**VILLAGE OF ARLINGTON HEIGHTS
STAFF DEVELOPMENT
COMMITTEE REPORT**

Project Number: PC 23-011
Project Title: 2201 N. Chestnut Townhomes
Location: 2201 N. Chestnut Ave., 315 W. Rand Rd.
PINs: 03-18-401-020, 03-18-401-021

To: Plan Commission
Prepared By: Sam Hubbard, Development Planner
Meeting Date: April 24, 2024
Date Prepared: April 19, 2024

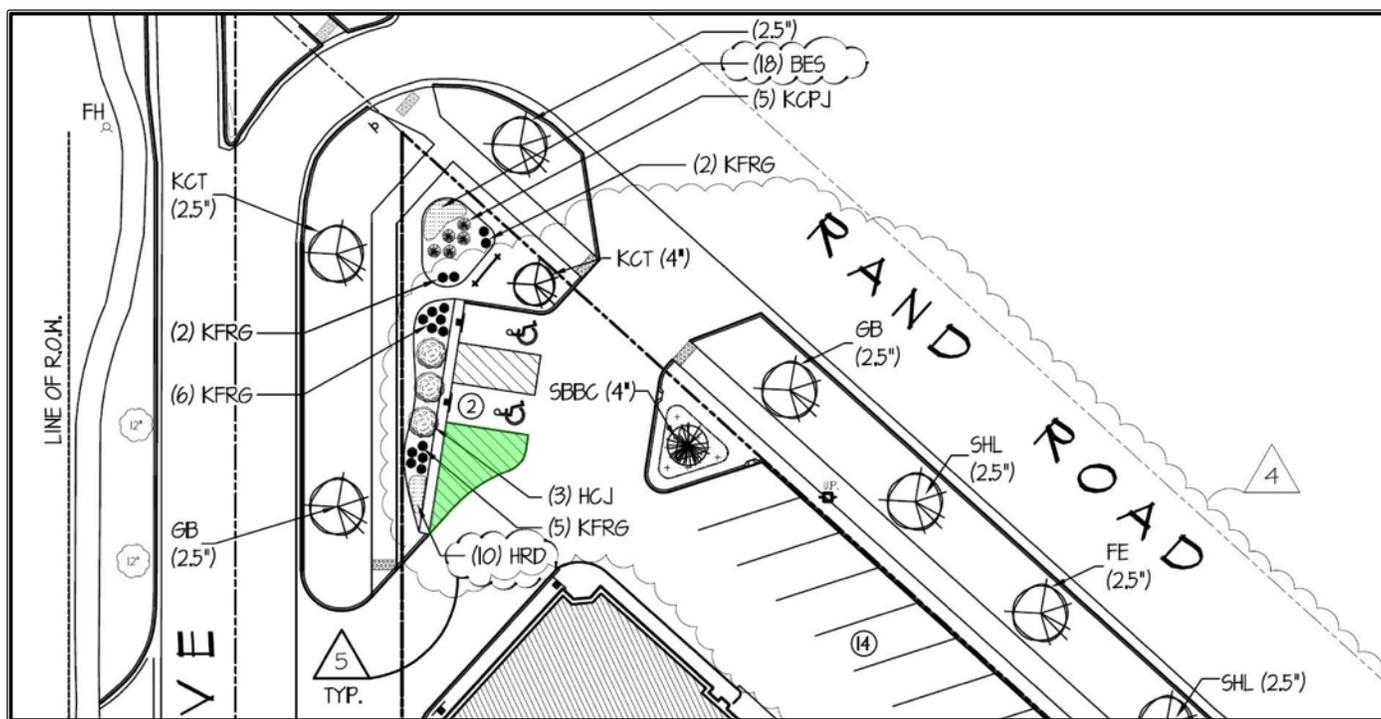
At the northern side of the site there is an area of existing pavement that is proposed to remain as striped asphalt adjacent to a parking stall. The graphic below shows this area in green.

Code requires that the ends of all parking rows include a curbed landscape island including a shade tree. The SDC recommends this area be converted to a landscape island including a shade tree and a condition of approval requiring such has been recommended below.

6. The striped area at the southern end of the two parking stalls located at the northern corner of the site shall be converted to a curbed landscape island including a 4-inch caliper shade tree.
